NEW YORK STATE THRUWAY AUTHORITY
DEPARTMENT OF ENGINEERING

AMENDMENT NO. 3
TO

CONTRACT TAN 26-9A
D215077
NIAGARA SECTION PUMPHOUSE UPGRADE
ON I-190, MP N9.1
IN THE BUFFALO DIVISION
OF THE NEW YORK STATE THRUWAY
IN ERIE COUNTY

IN THE LETTING OF
MAY 6, 2026

A2 CONTROLS BUILDING - LIGHTING PLAN
SCALE: 3/16" = 1'-0"

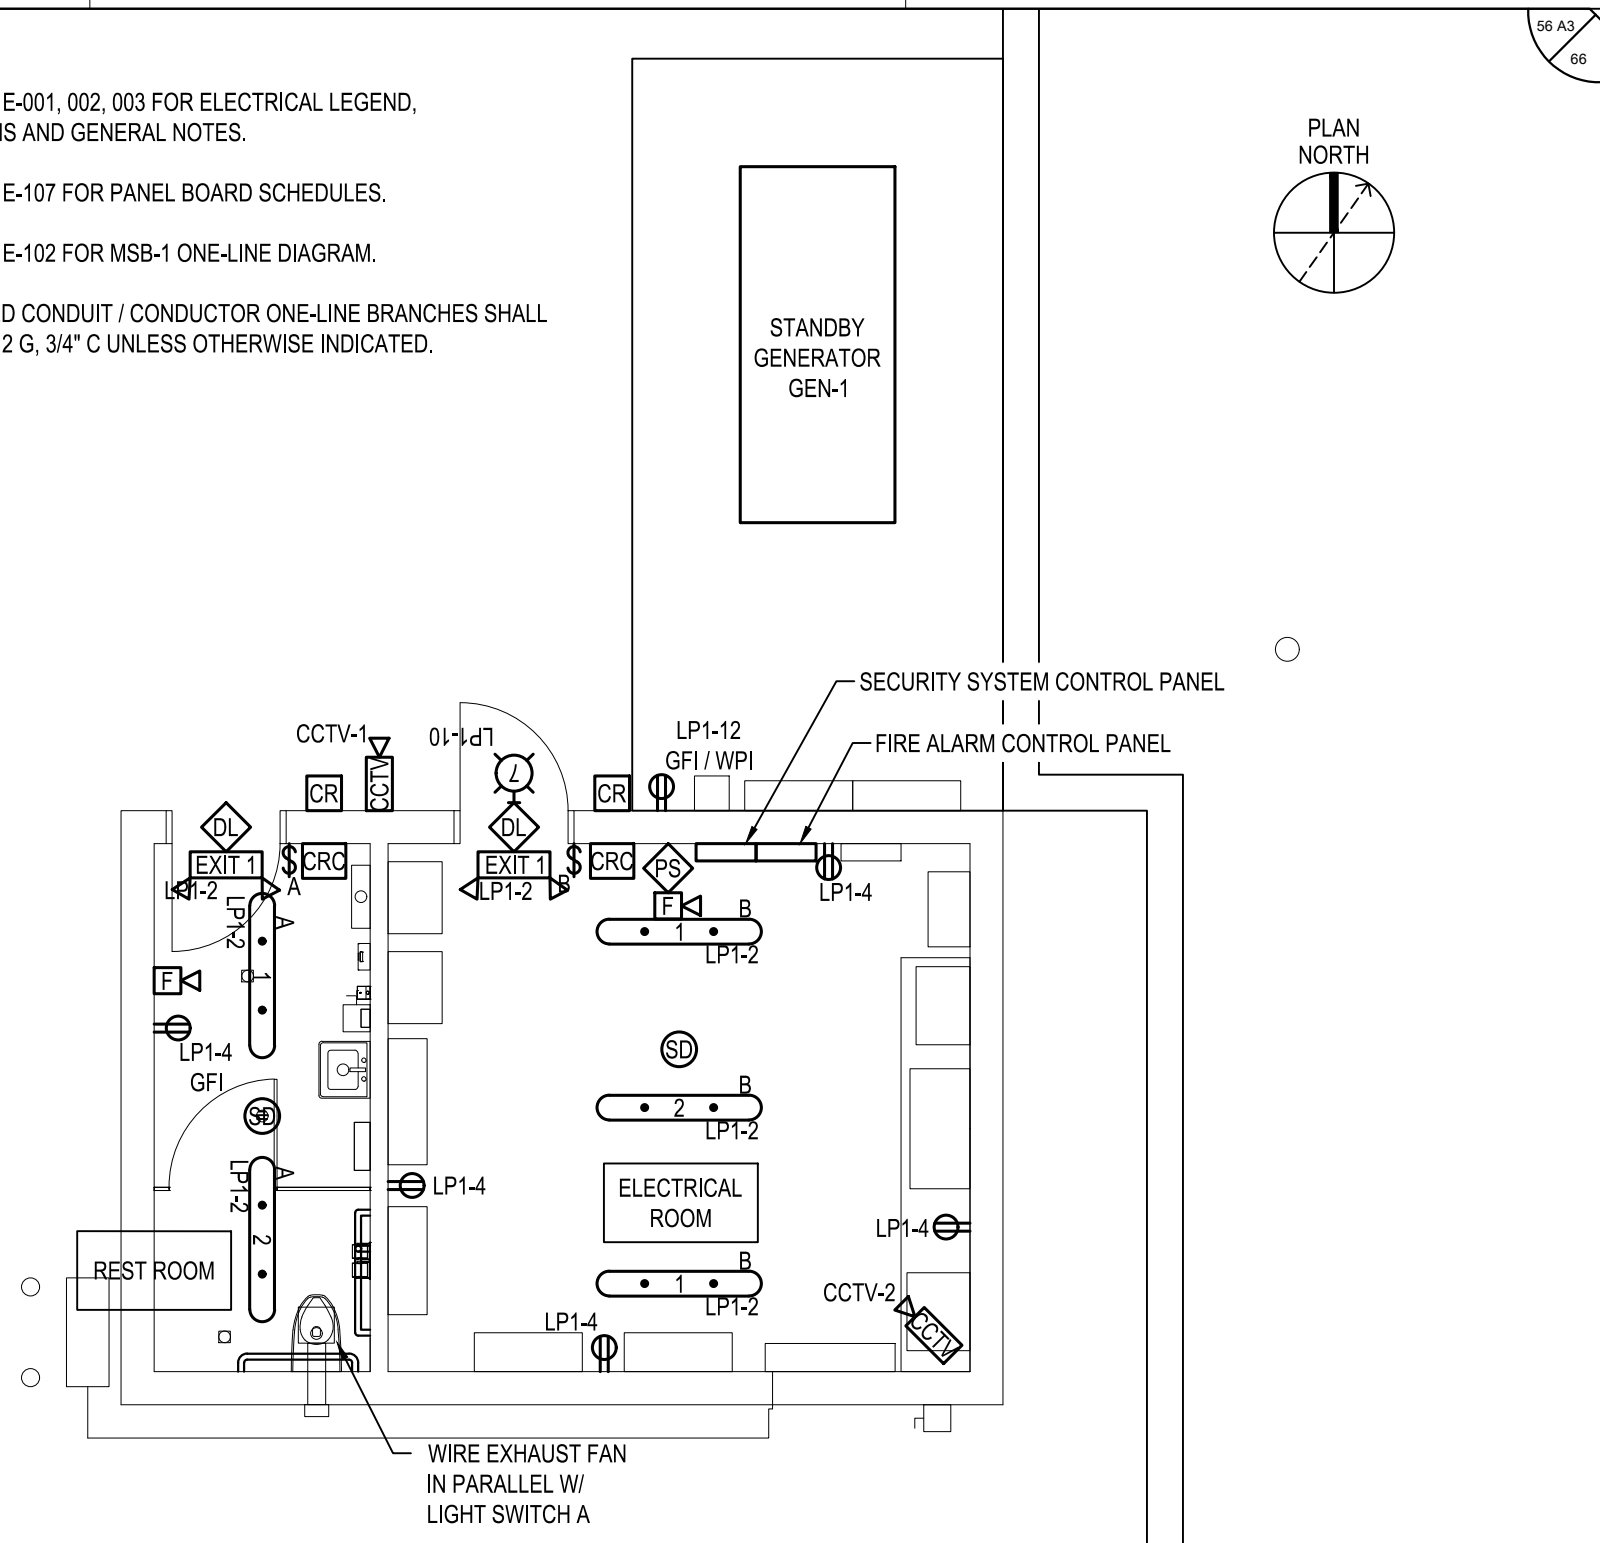
12. **DELETE** Drawing Number E-106, Sheet 56 of 66 and **SUBSTITUTE** with the attached Drawing Number E-106, Sheet 56-A3 of 66. The A2 Controls Building - Lighting Plan detail has been updated to call out the wall fan installation coordination with the proposed light switch.
